STAFF REPORT: SEPTEMBER 13, 2023 REGULAR MEETING

APPLICATION NUMBER: 23-8525

ADDRESS: 12632 (12638) DEXTER

SCOPE: INSTALL STONE AND STUCCO VENEER

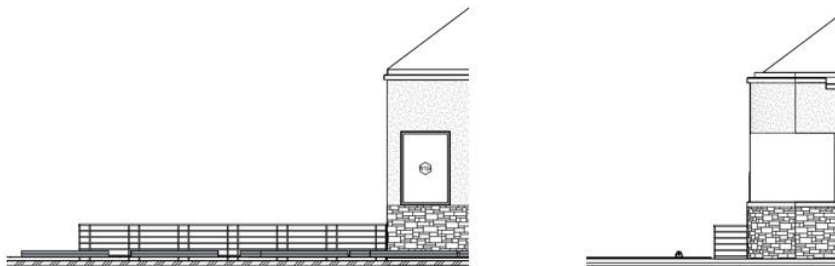
- In general, the Secretary of the Interior’s Standards for Rehabilitation require that character-defining features of a building be preserved. “Character-defining elements include the overall shape of the building, its materials, craftsmanship, decorative details ... as well as the various aspects of its site and environment.”¹ As noted above, the curved brick walls, including their color and texture, along with brick dentils, are character-defining features; the smooth block and the contrast that it provides with the brick are also important to the character of the building. Standard #2 directs that the “alteration of features and spaces that characterize a property shall be avoided.” The proposed plaster and stone veneer would alter the character of the building, contrary to Standard #2.

- As an additional note, the application does not provide specifications for the “plaster” (the word can broadly include different materials and techniques) or a product name for the proposed stone veneer. Staff has asked for this information. Regardless, stone veneer is not appropriate for Art Moderne buildings in general. Stucco plaster, while sometimes found on Art Moderne buildings, is not historically appropriate for this building and is not found on Art Moderne buildings in the Russell Woods-Sullivan Historic District as a whole (the examples mentioned above are all brick).
- The application does not provide a narrative or specifications regarding the proposed fence materials, finish, and color. This will be required to make a final determination as to its appropriateness. Staff has asked for additional information regarding the proposed fence.

- The proposed work would alter the character of the building by obscuring character-defining features including textured and patterned brick, mortar joints, and concrete block.
- The proposed stone cladding, specifically, introduces a novel texture and finish that is not compatible with the Art Moderne style of the building, not compatible with the period of significance of the Russell Woods-Sullivan Historic District, and not compatible with other historic buildings found within the district. The proposed plaster finish is also incompatible with the district.

Therefore, staff recommends that the Commission issue a Denial for the proposed plaster and stone veneer installation as the proposed work fails to meet the Secretary of the Interior's Standards for Rehabilitation, in particular:
